Job Title:  
MILL LANE CLONDALKIN APARTMENTS

Drg Title:  
BLOCK B  
NORTH EAST ELEVATION

Drg No.:  
200301-C-207-K

CONSTRUCTION DRAWINGS

**BLOCK B  
NORTH EAST ELEVATION**

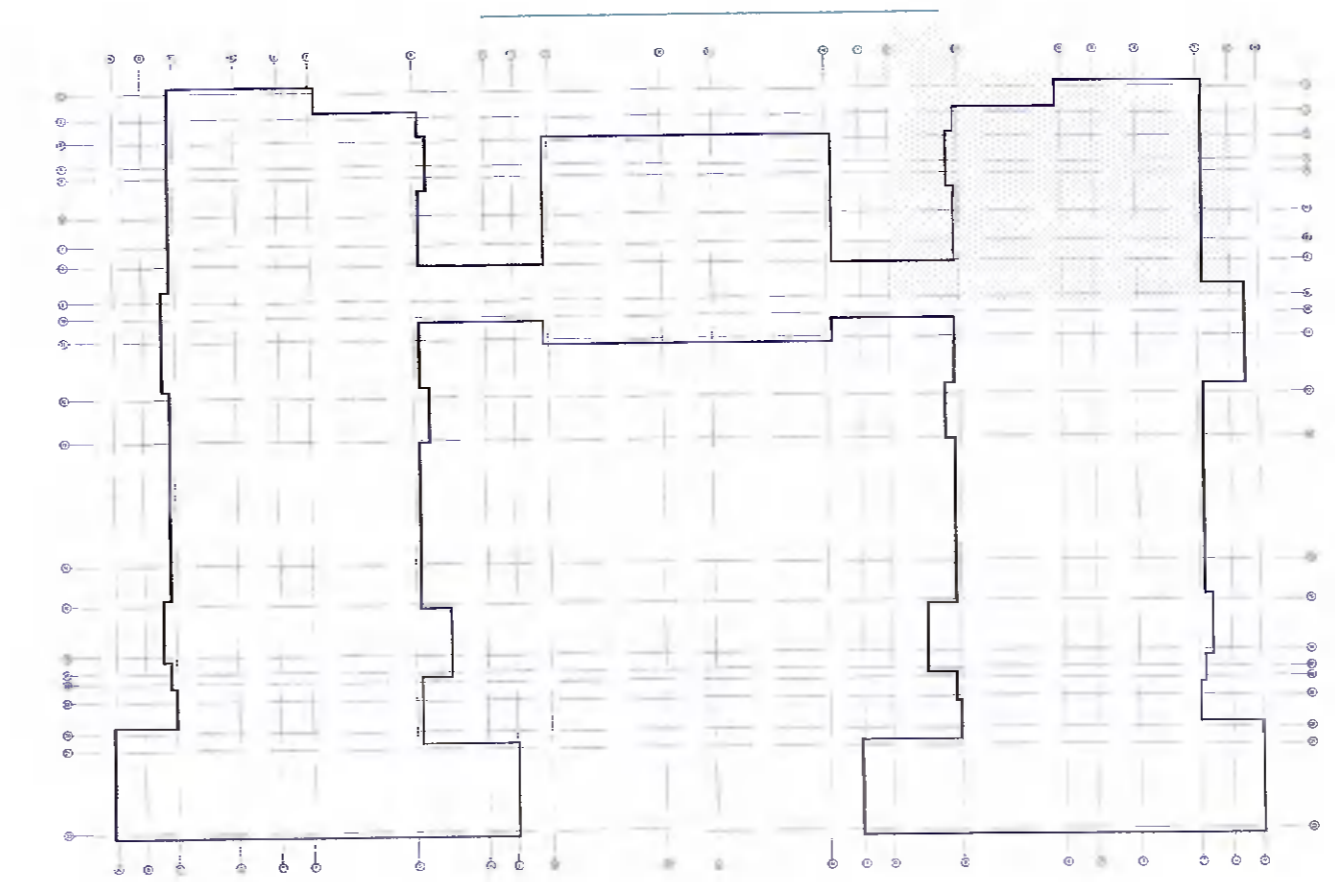
- REV A: 21/12/2020  
- RAIN WATER PIPE LOCATIONS ADDED THROUGHOUT
- REV B: 02/03/2021  
- WINDOWS UPDATED THROUGHOUT TO MATCH WINDOW SCHEDULE REV A AND COMMENTS FROM MEETING WITH MUNSTER JOINERY ON 26/02/2021

- REV D: 21/07/2021  
- STEEL BALCONIES REVISED THROUGHOUT  
- ALTERATIONS TO GROUND FLOOR BLOCK B WINDOW 156 TO MATCH NEW LAYOUT AS PER CLIENT REQUEST

- FACADE MATERIALS UPDATED AS PER DESIGN TEAM MEETING ON 15TH JULY 2021  
- GROUND FLOOR FOYER WINDOW LAYOUT UPDATED AS PER CLIENT REQUEST  
- WINDOW TYPE S UPDATED AS PER CLIENT REQUEST

- REV E: 14/09/2021  
- WINDOW NUMBERS REVISED TO REFLECTED UPDATED WINDOW SCHEDULE
- REV F: 05/10/2021  
- WINDOWS BLOCKED UP INTERNALLY INDICATED HATCHED ON DRAWINGS.

- DOWNPIPES TO BALCONIES ADDED AS INDICATED  
- NIB WALLS ADDED TO FIRE ESCAPE DOORS AS ADVISED BY FIRE CONSULTANT
- REV G: 11/10/2021  
- PETRARCH CLADDING CHANGED TO FIBRE-CEMENT THROUGHOUT

- REV H: 27/10/2021  
- FIBRE-CEMENT CLADDING CHANGED TO PETRARCH OR RENDER CLADDING AS INDICATED ON DRAWINGS  
- PRECAST BALCONY BALUSTRADES CHANGED FROM GLAZING TO PETRARCH PANELS.

- REV J: 10/11/2021  
- GRID LINES ADDED  
- EXPANSION JOINTS TO RENDER AREAS ADDED
- REV K: 30/11/2021  
- LOW CONCRETE BLOCK WALLS DENOTING GROUND FLOOR EXTERNAL PRIVATE AREAS ADDED TO ELEVATIONS. CONC WALLS TO BE RENDERED AND FINISHED WITH GRANITE CAPSTONE.
